Chilled Water Plant Improvements Project Solicitation Number: CO-00051 Job No.: 15-7502

ADDENDUM 2

February 9, 2016

Item No. 5: Sheet L4.1

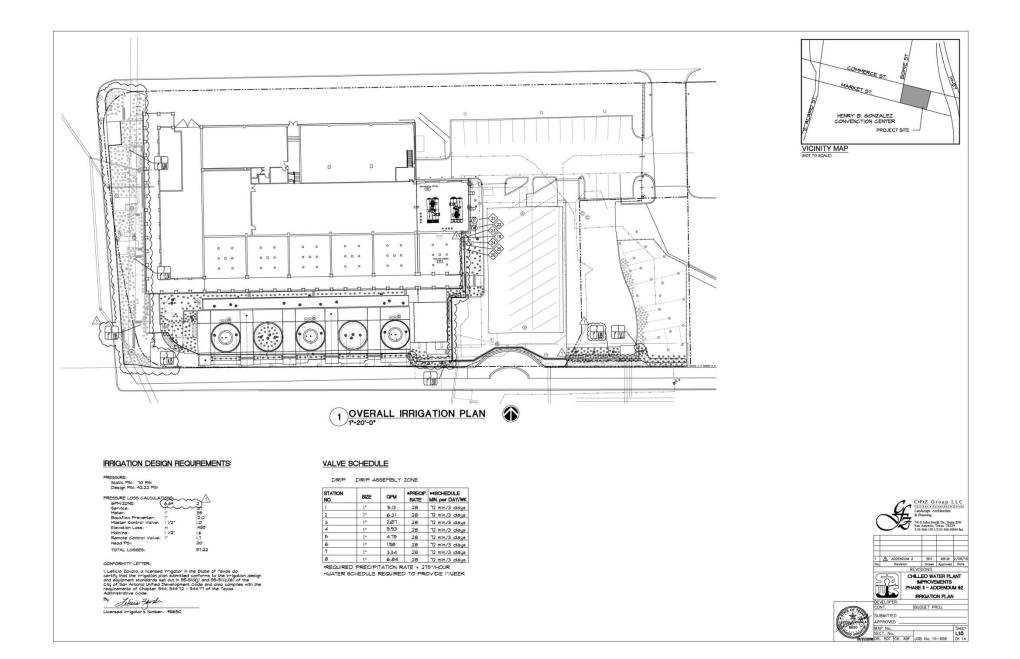
1. Question: The 8,700 sf Asphalt chip seal shown on the bid proposal is suspect for area defined in the plans. Please confirm quantity.

A. Revised chip seal area

Answer: Page BP-2 ALT P-1 Change 8,700 sf to 22,210 Sq.ft. See updated drawing issued with this addendum for area to receive chip seal.

L4.2

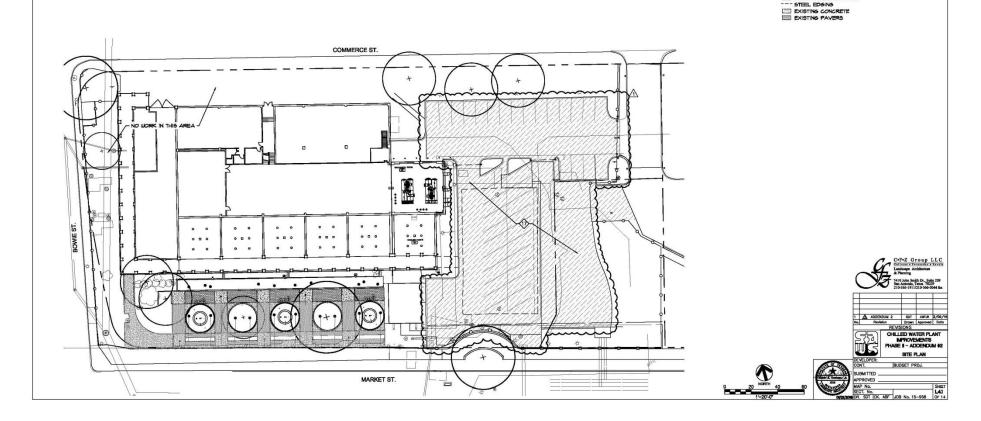
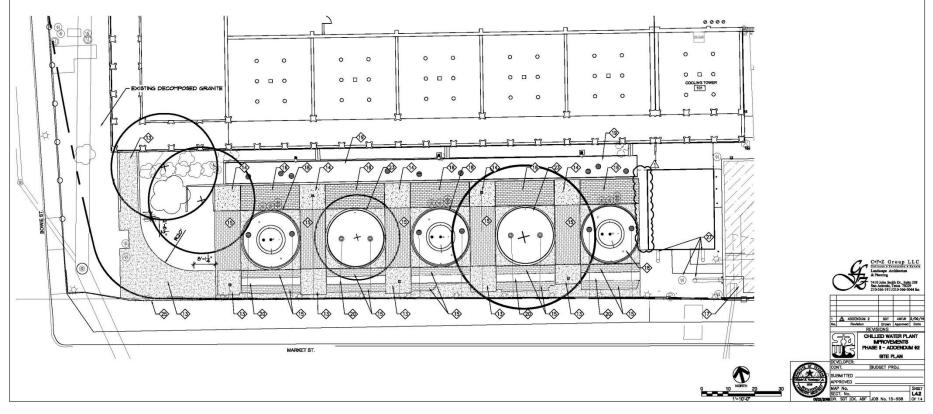
A. Deleted decomposed granite between courtyard and building (granite is existing in this area)
